Title: 713th Meeting - Advisory Committee
on Reactor Safeguards

Date: Wednesday, March 6, 2024

SRM-SECY-22-0076 Implementation: Branch Technical Position 7-19, Revision 9

Model the CCF in the PRA

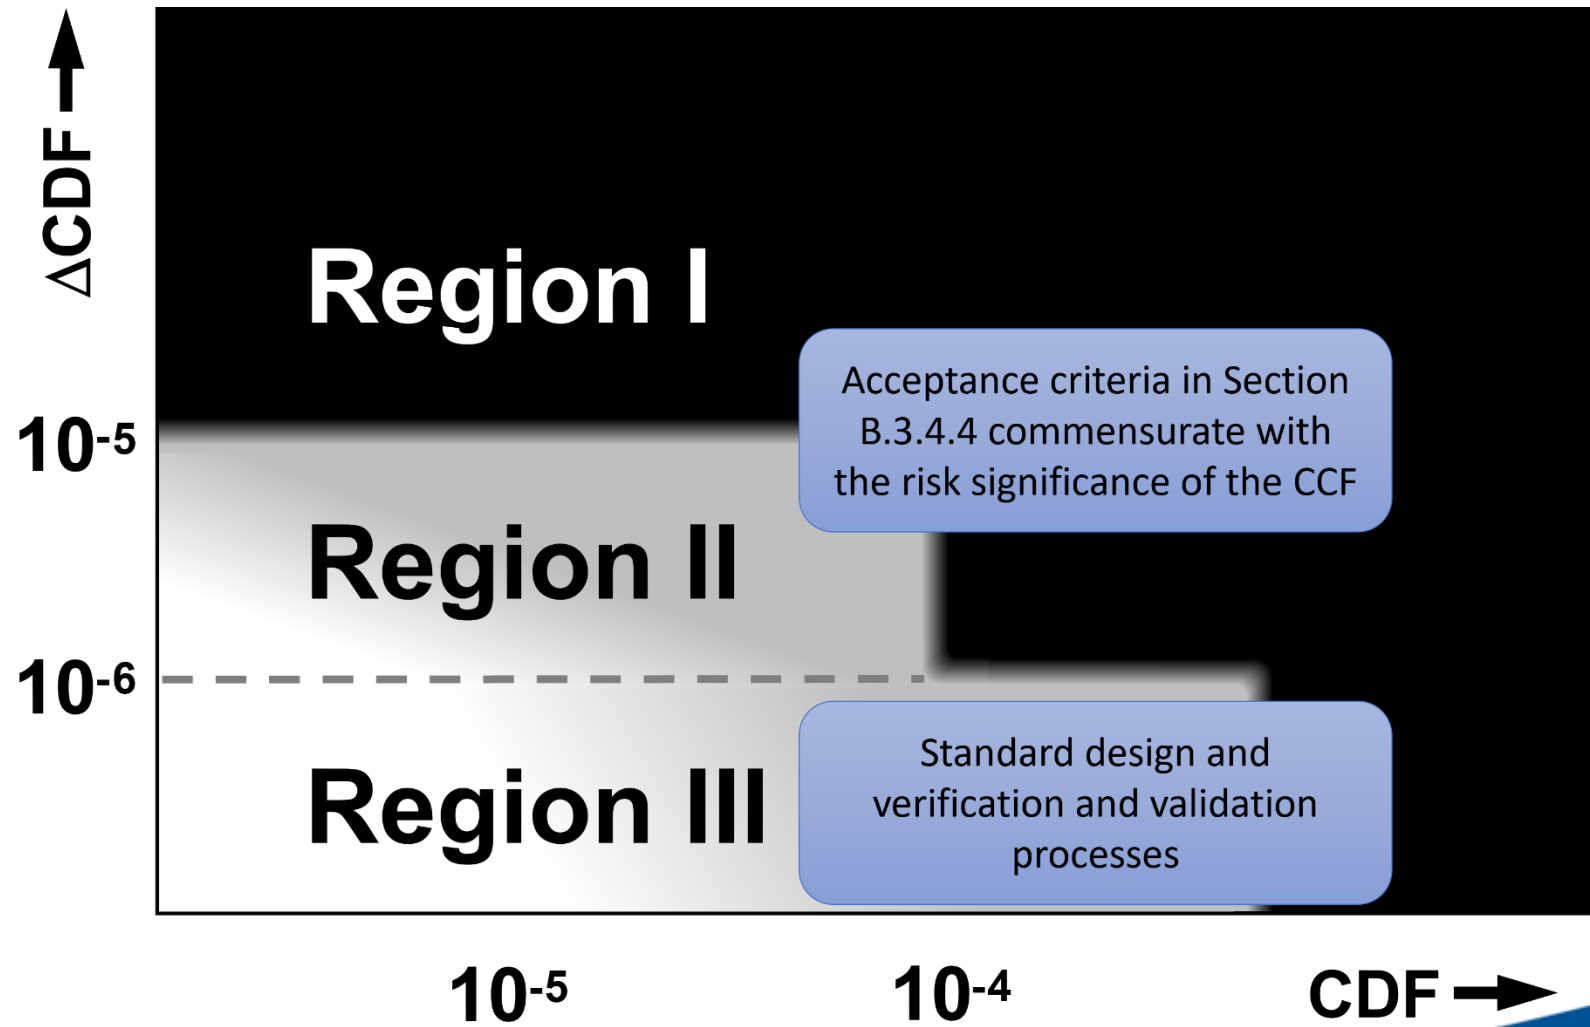
10 MEMBER PETTI: Question, as I understand
11 it, PRAs today don't model the digital I&C system. So
12 this is a pretty high bar. This is a big scope change
13 to PRA, right, to include this for all the digital
14 I&C.

15 CHAIR KIRCHNER: I just struggle over the
16 conservative in quotation marks in that bullet. I
17 understand doing a sensitivity analysis that assumes
18 a probability less than one. But then they have to do
19 what you ask for next. They have to have the
20 technical basis for it and then see what the impact on
21 the system in question is. But I just don't see how
22 that's conservative versus Bullet No. 2.

18 MR. ALFERINK: -- comment. So in general,
19 CCF can be modeled in the PRA either through detailed
20 modeling of the digital I&C system or the use of
21 surrogate events which in the existing basic events --

4 MR. ALFERINK: What I'd expect them to do
5 is if they identified which components the CCF would
6 impact. You could potentially just fail that sort of
7 components. So I would say it's more like the basic
8 event level. You go through, fail those, look at what
9 the change in risk would be.
